Transport
for NSW

Heathcote Road Bridge

Addendum Review of
Environmental Factors

April 2022

Figure 3-8 Cross section of northern approach – Ch 200

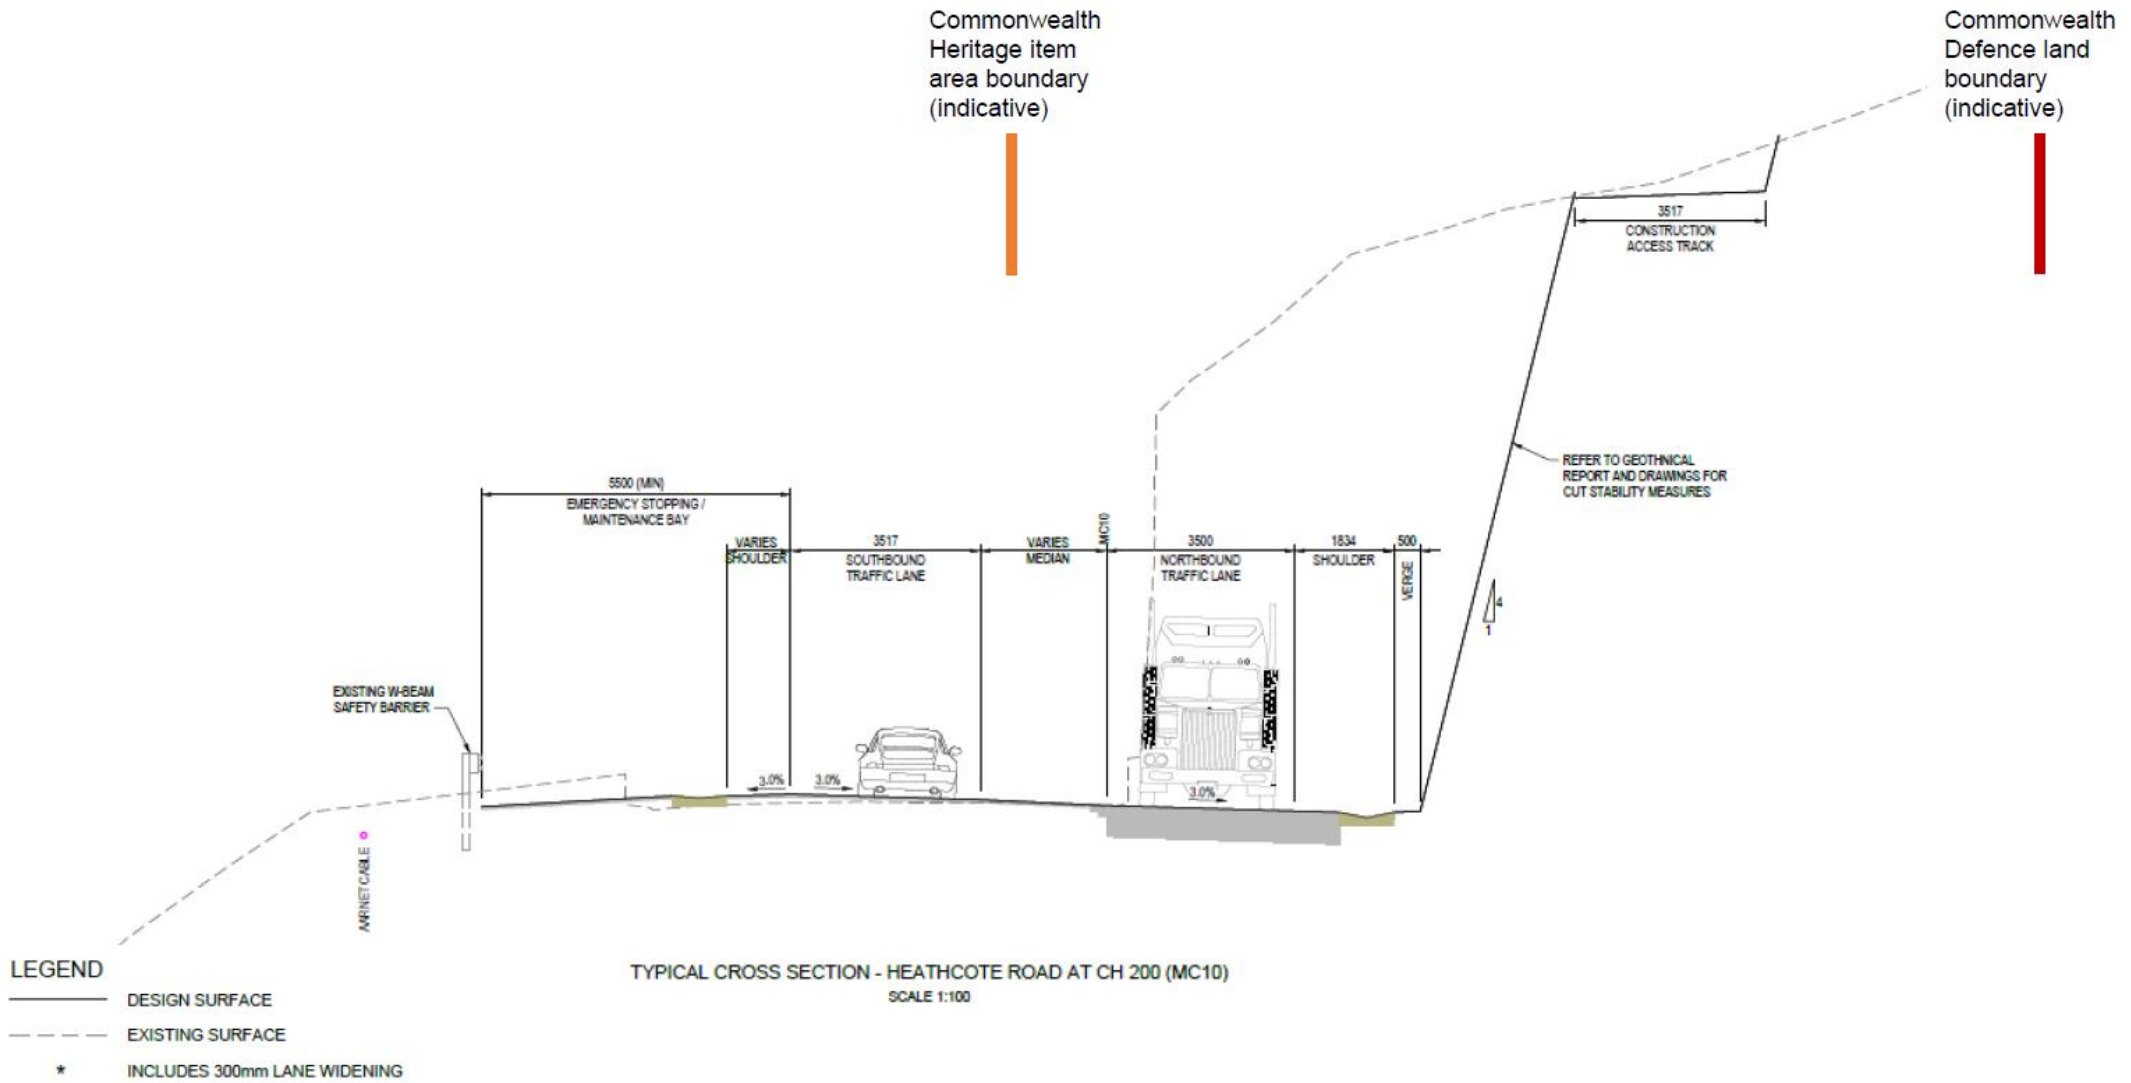
Figure 3-7 and Figure 3-8 shows cross sections of the proposed upgrades to the northern approach. Figure 3-1 indicates the chainage locations for these figures.

The proposed modification would require additional excavation on the rock cutting located on the north-west side of the existing bridge (refer to Figure 3-1). This cutting would be accessed from the top to allow materials to be safely and efficiently removed. The extent of the cutting varies but is generally about nine metres at the southern end, five to seven metres in the mid-point of the cut and tapering from three to zero metres at the tie-in on the northern extent. The north-west rock cutting is about 150 metres long in total. This cut is also shown in Figure 3-7 and Figure 3-8.

Figure 3-10 Cross section of southern approach – Ch 420

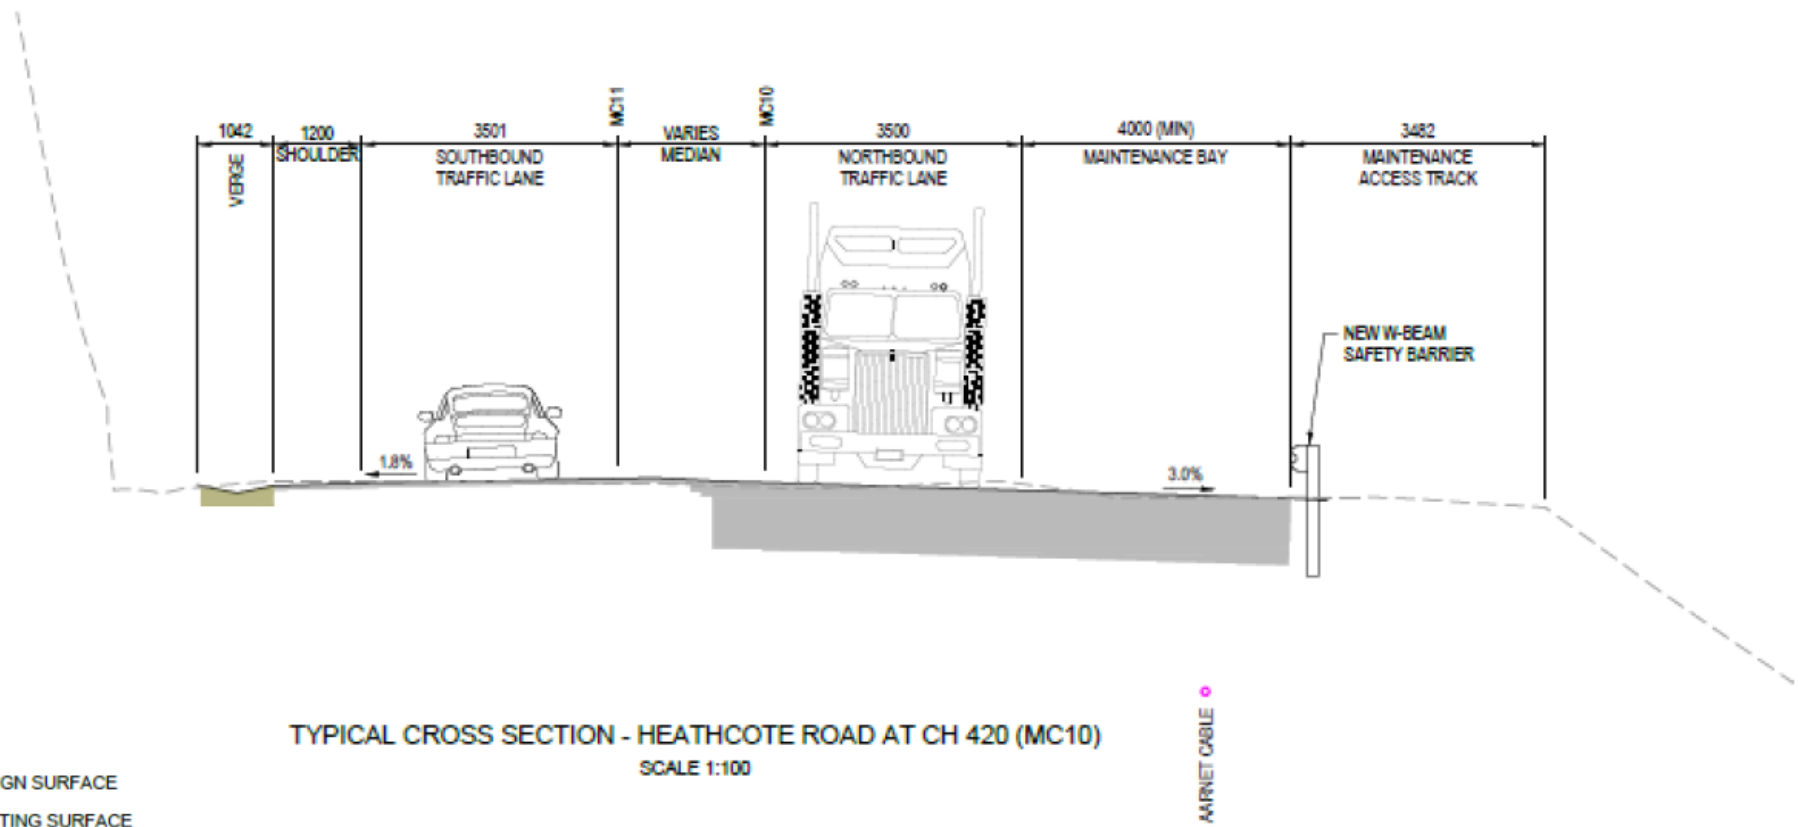
Figure 3-10 shows cross sections of the proposed upgrades to the southern approach. Figure 3-1 indicates the chainage location for this figure.

Figure 3-11 Existing and new bridge deck drainage strategy

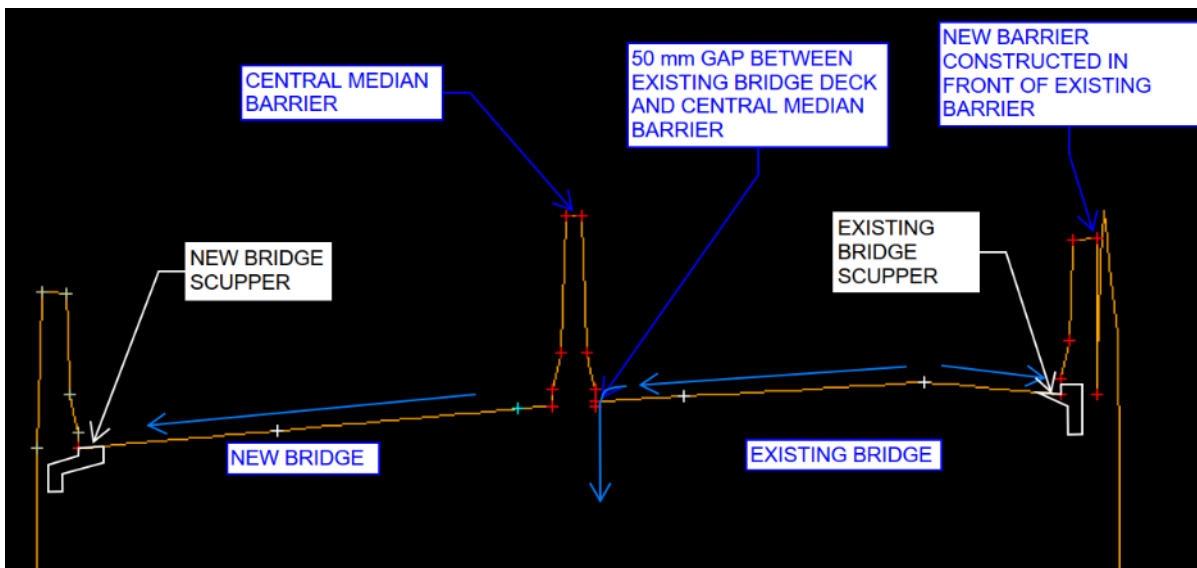
- open scuppers on the new bridge draining into the river at four metre intervals. On the existing bridge, scuppers would be blocked on one side of the bridge and crossfall adjusted so that the water drains to one side only (refer to Figure 3-11).
- new longitudinal alignment drainage discharging at the bridge abutments.
- a new longitudinal drainage line at the northern extent of the modified project boundary, preventing upstream water sheet flowing over Heathcote Road.
- upgraded bench drainage on the north-west cut, diverting water away from the northbound carriageway.

Figure 3-12 Proposed drainage line about 30 metres north of the approved REF boundary

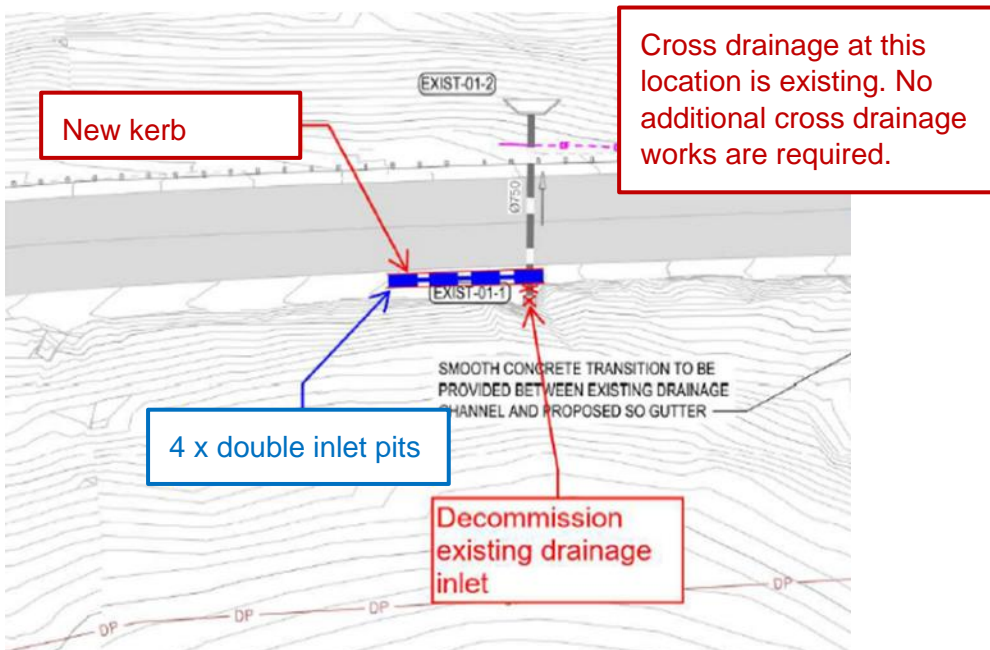
On the northern approach, the current drainage network which takes waters flowing from the north towards the approved project boundary is insufficient to divert upstream flows. As a result, there are sheet flows towards the approved project boundary which have been known to cause water planing on the existing bridge and create a hazard to road users. To prevent this, an upgrade to a cross drainage line about 30 metres to the north of the approved project boundary would be required (refer to Figure 3-12). This proposed drainage line upgrade would divert drainage away from the proposed modification and has been included in the modified project boundary.

Figure 3-16 Alignment of existing fibre optic cable and bridge piers

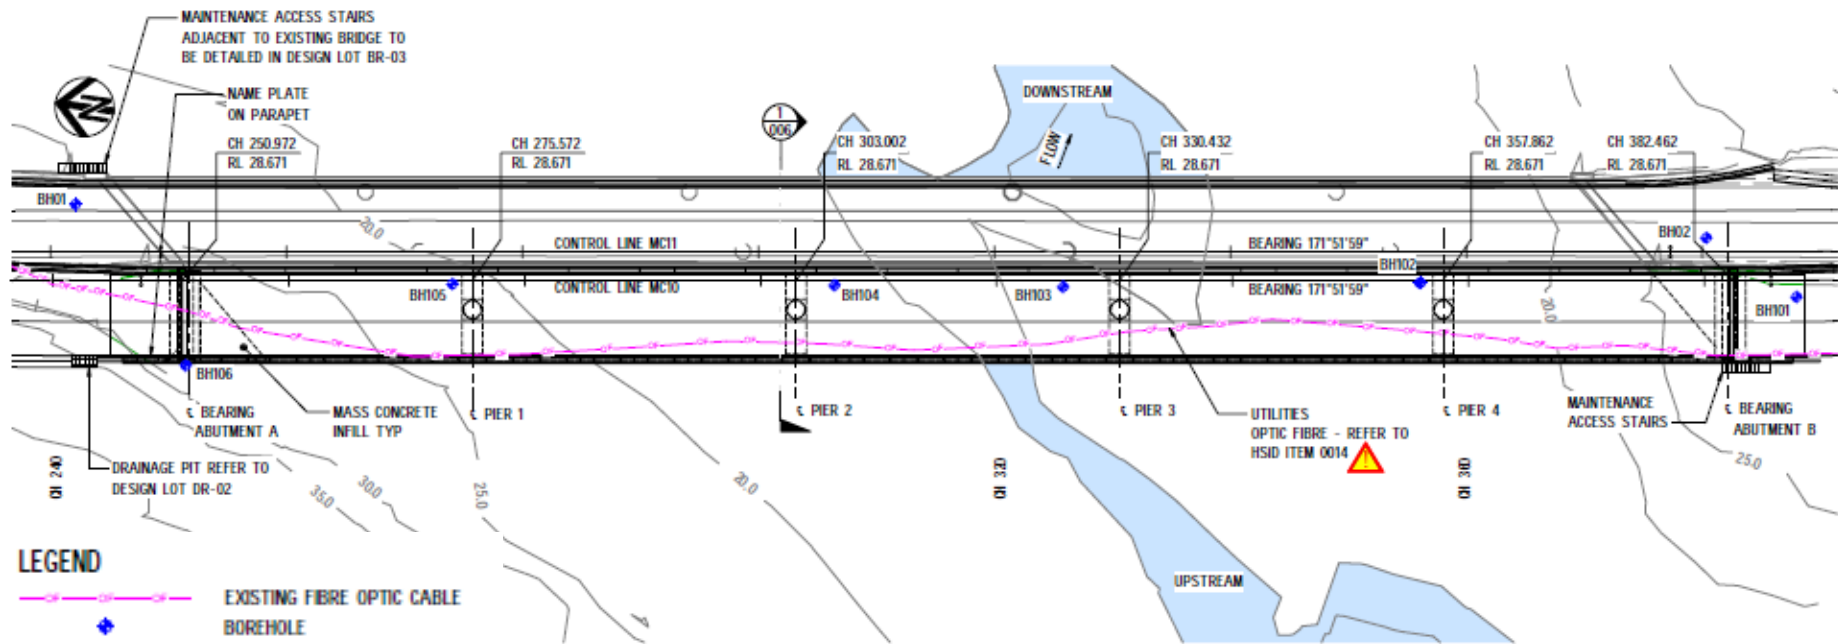
The proposed modification would not require public utility adjustment as the pile arrangement for the new bridge has been optimised to avoid impacts to the existing AARNet fibre optic cable (refer to Figure 3-16).
